Access Compliance Report Public Rights-of-Way (Curb Ramps)

Intersection ID: 10017853 Main Street: N_GRAHAM_ST Cross Street: N/A Location: S

ADA ID: B820AF4B5371 Ramp Type: PerpDiag Initial Pass/Fail: Fail Overall Compliance: No Severity Score: 25

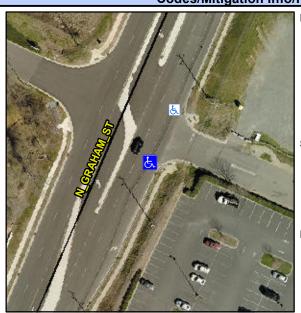
Not Found, R304.5.3

r leid Measurements/Component Compilance						
	Compliance Description		Data	Compliance Description		Data
	N/A	Ramp Length (in)	85.0	Yes	Ramp Slope (%)	6.6
	Yes	Ramp Width (in)	53.0	No	Ramp XSlope (%)	9.3
	N/A	Flare Type LT	N/A	N/A	Flare Type RT	N/A
	N/A	Flare Slope LT (%)	N/A	N/A	Flare Slope RT (%)	N/A
	N/A	Flare Traversable LT?	N/A	N/A	Flare Traversable RT?	N/A
	N/A	Landing Length (in)	N/A	N/A	DWS Provided?	N/A
	N/A	Landing Width (in)	N/A	N/A	DWS Contrast?	N/A
	N/A	Landing Slope (%)	N/A	N/A	DWS Length (in)	N/A
	N/A	Landing X Slope (%)	N/A	N/A	DWS Full Width?	N/A
	N/A	Landing Curb? (Y/N)	N/A	N/A	DWS Offset (in)	N/A
	N/A	Shared Landing?	N/A			
	N/A	Gutter Ponding?	N/A	N/A	Gutter Slope (%)	N/A
	N/A	Gutter Lip Ht (in)	N/A	N/A	Gutter X Slope (%)	N/A
	N/A	Painted X Walk1?	No	N/A	Painted X Walk2?	No
		X Walk 1 Direction	To NE		X Walk 2 Direction	To NW
	N/A	X Walk 1 Width (in)	N/A	N/A	X Walk 2 Width (in)	N/A
		X Walk 1 Slope (%)	1.2		X Walk 2 Slope (%)	7.3

ENTRANCE StopSign N GRAHAM ST None Possible Solutions:

Remove & Replace Curb Ramp With Two New Directional Ramps or Equivalent.
